SUBJECT: Transmittal of Revised Westinghouse Proprietary and Non-Proprietary Responses to U.S. Nuclear Regulatory Commission Requests for Additional for the AP1000 Application for Design Certification

Westinghouse Revised Non-Proprietary Responses
to US Nuclear Regulatory Commission
Requests for Additional Information
dated March 17, 2003

AP1000 DESIGN CERTIFICATION REVIEW

Figure 440.091-11 Upper Plenum Pressure

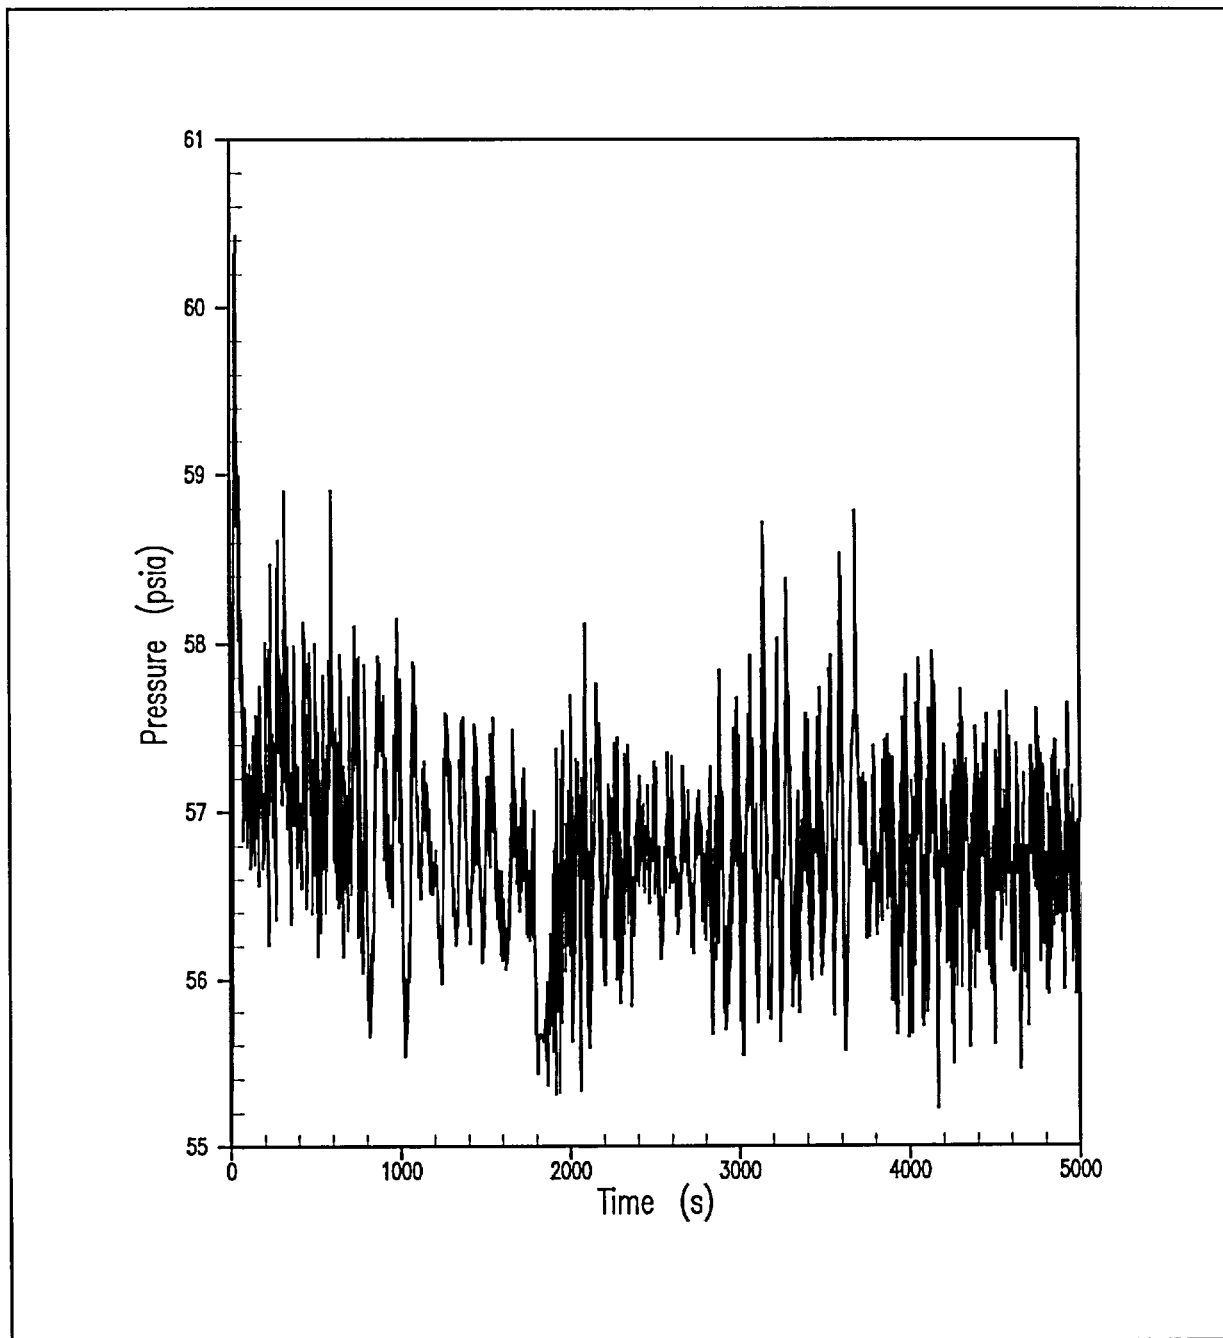
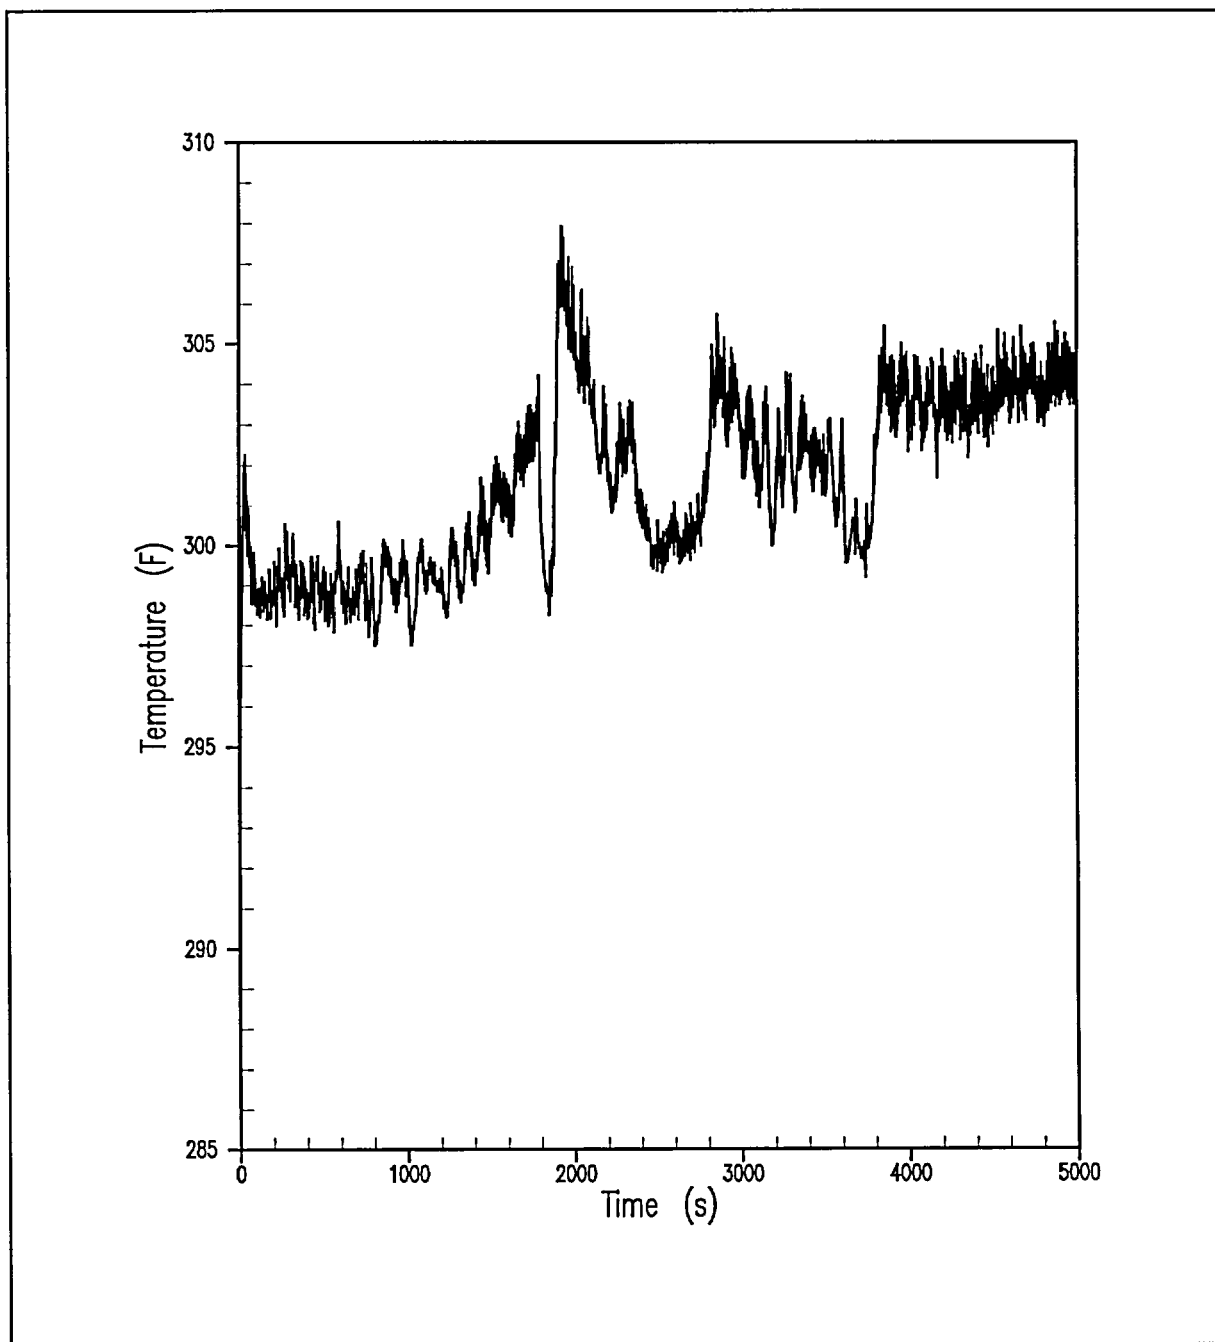
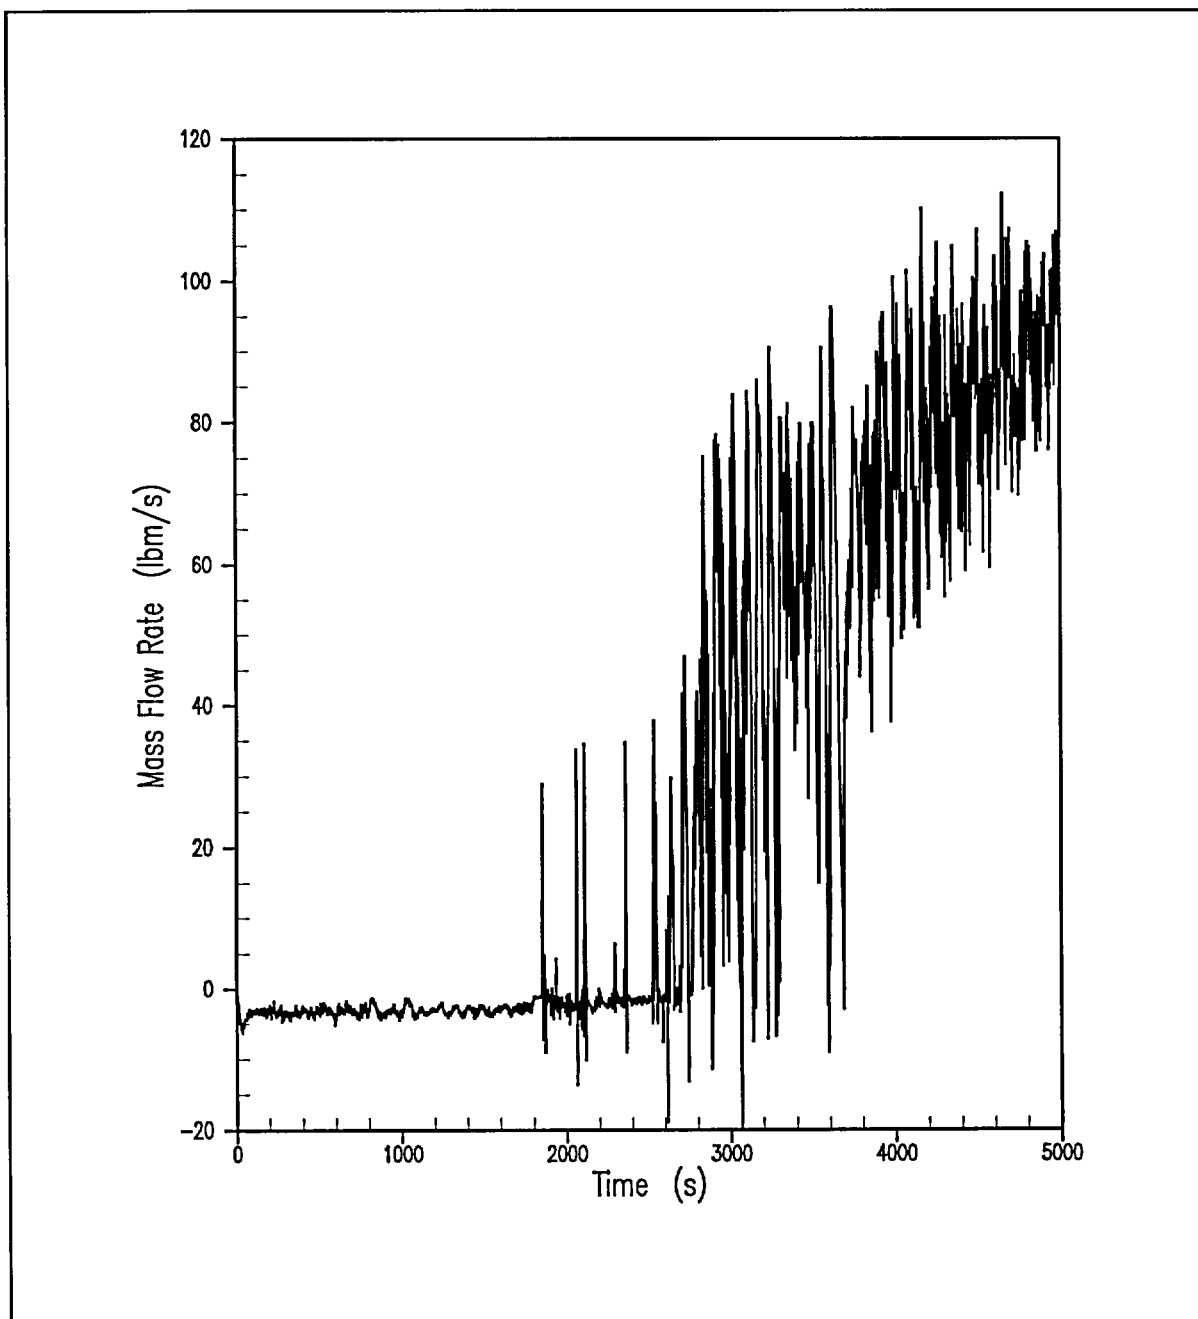
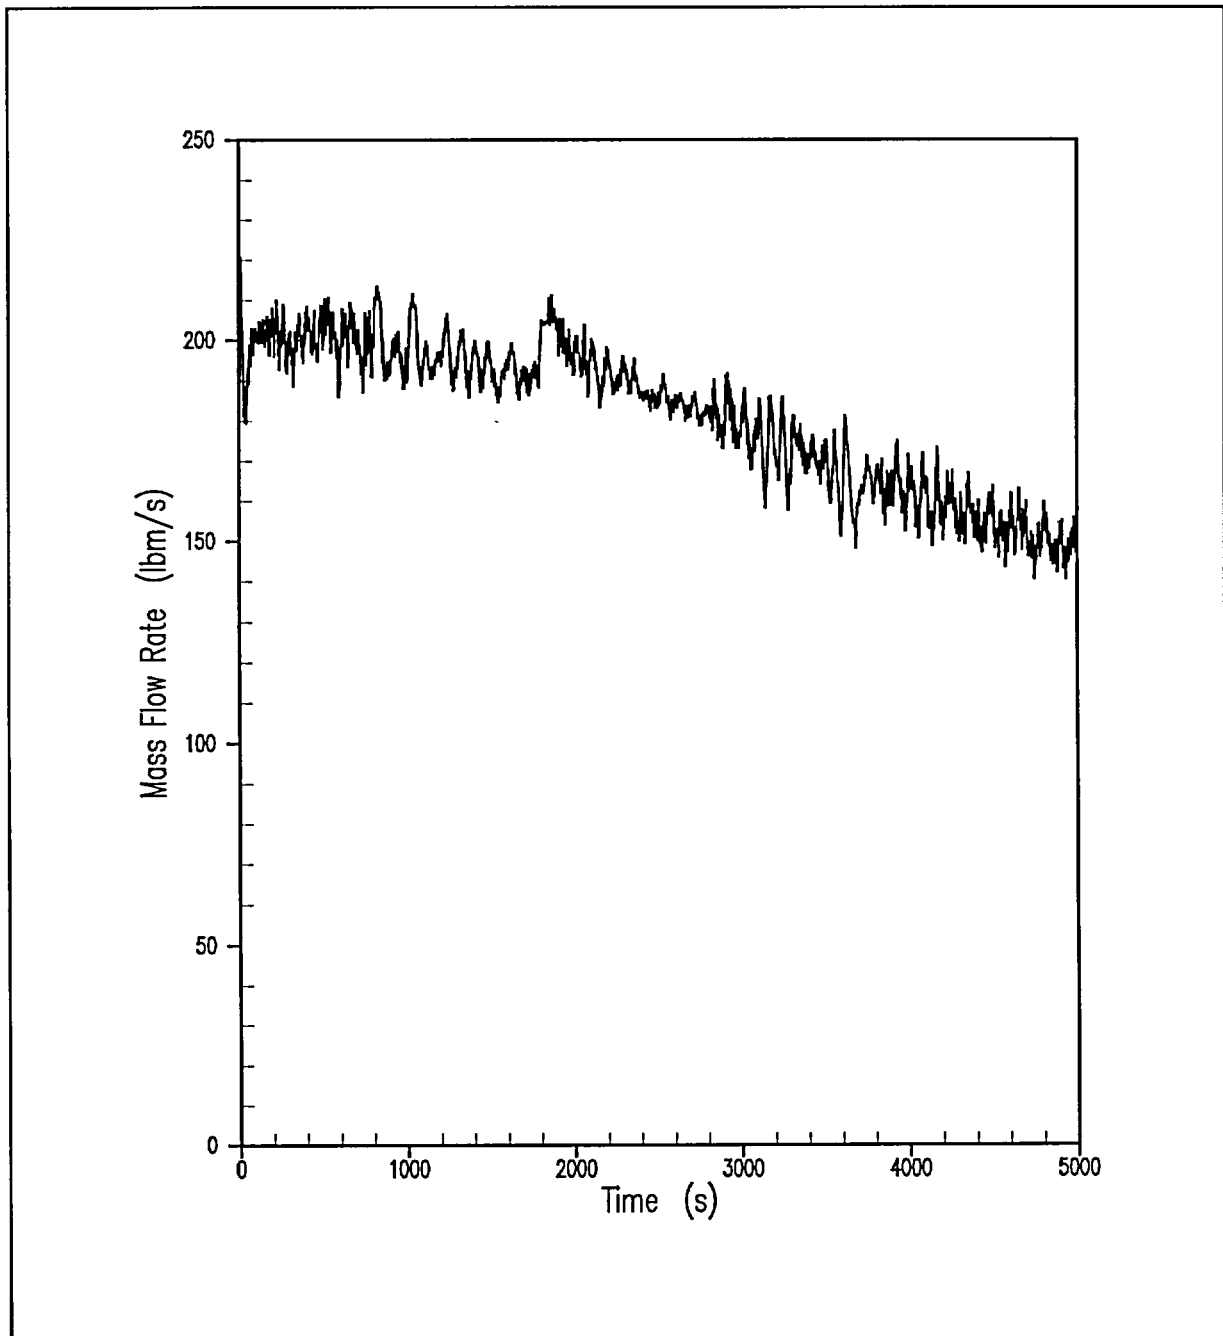
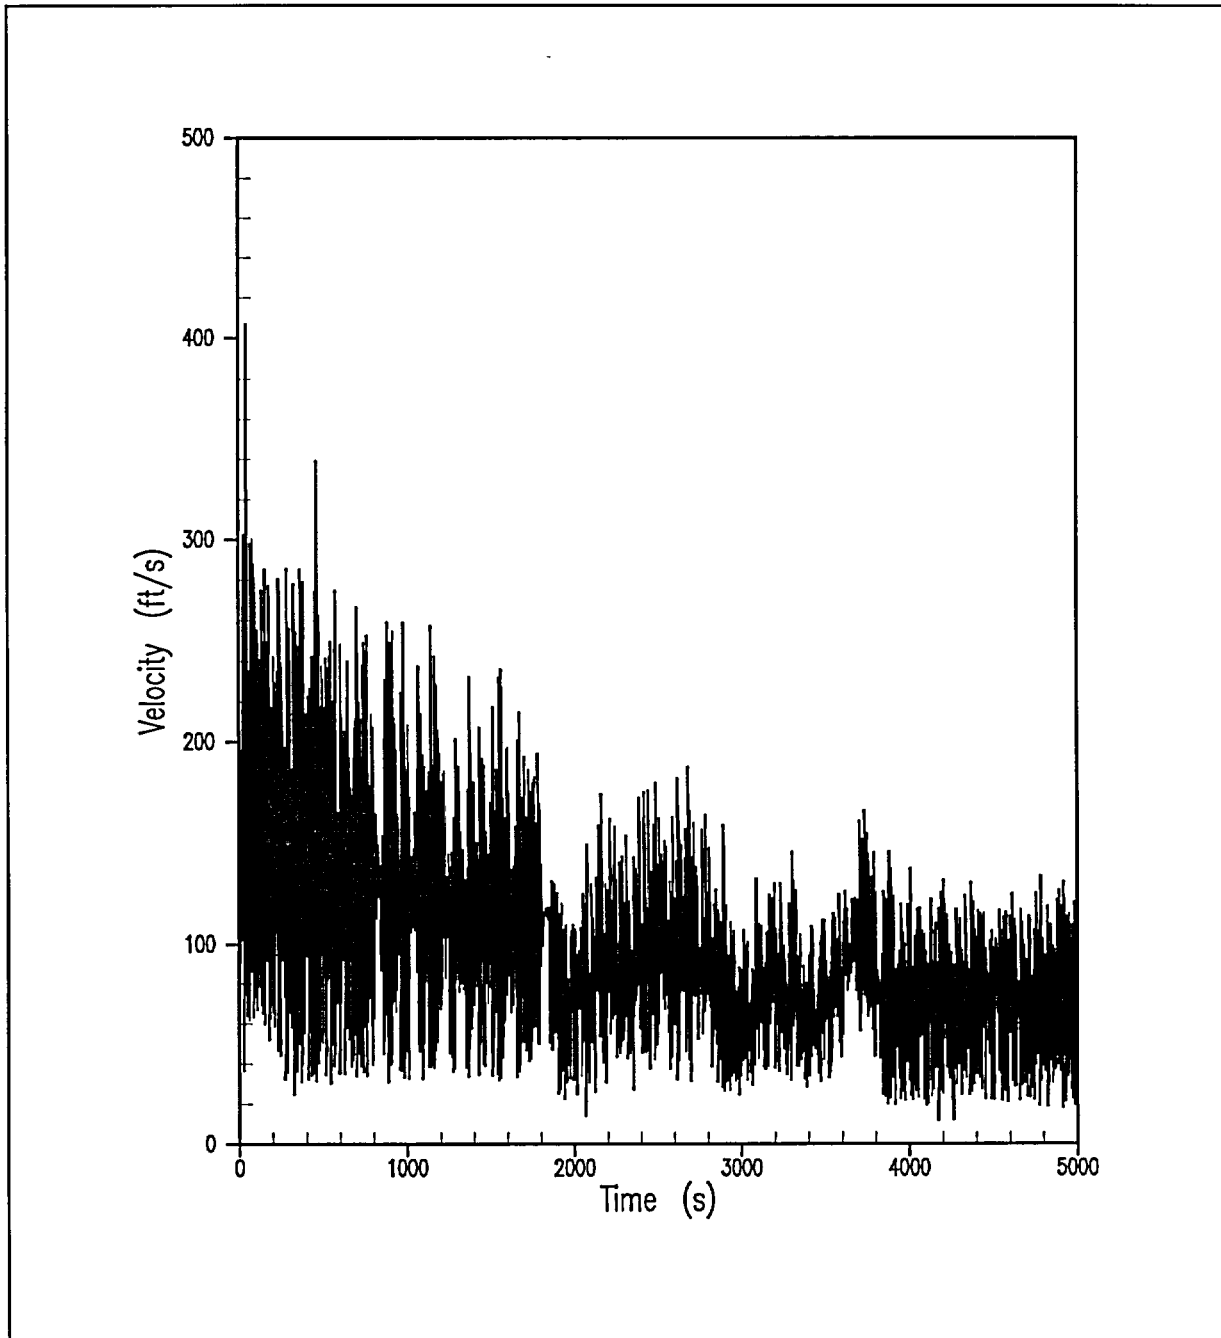
Will that steam velocity be able to entrain and remove liquid from the core? (Note, it is not feasible to draw this conclusion from the information in the code applicability report without extensive calculations.)

The question is concerned with the removal of liquid from the AP1000 core / upper plenum at a minimum steam velocity condition. The concern is whether there exists sufficient liquid carryover out the ADS-4 valves post-LOCA to prevent the potential for boron precipitation in the reactor vessel. As was demonstrated for the AP600, liquid carryover from the ADS-4 valves prevents the reactor vessel boron concentration from approaching the concentration where boron would precipitate. A boron concentration of approximately 35,000 ppm at 240F is necessary to cause boron to precipitate out of solution. Bounding calculations performed for the AP1000 have determined that the maximum post-LOCA boron concentration calculated for the limiting long-term cooling analysis cases presented in the DCD is 5500 ppm. This represents a large margin to the value where boron precipitation could be a concern.

A set of figures is provided presenting the results obtained from the WCOBRA/TRAC run for this scenario. Liquid flow through the ADS-4 flow paths is adequate to ensure that boron will not concentrate in the core. As seen on Figure 440.091-15, the average steam velocity through the ADS-4 Stage 4A flow path in the offtake pipe from the hot legs is 95 ft/sec, while in the DCD case the average steam velocity at the same location is almost 300 ft/sec (Figure 440.091-16). Overall, the figures show that amount of liquid carryover is increased for this scenario. As seen in comparison to the DEDVI long-term cooling analysis results presented in the DCD, the vessel injection is greater, and reactor vessel level is higher throughout the transient. This is primarily due to the faster RCS depressurization resulting from all four ADS-4 valves opening. Even though the vapor velocity in the ADS-4 flow paths is reduced, the core remains covered and cooled, and the liquid carry-over out the ADS-4 is increased (when compared to the cases presented in the DCD). Thus boron precipitation in the reactor vessel will not be a concern for the postulated scenario raised in this RAI.
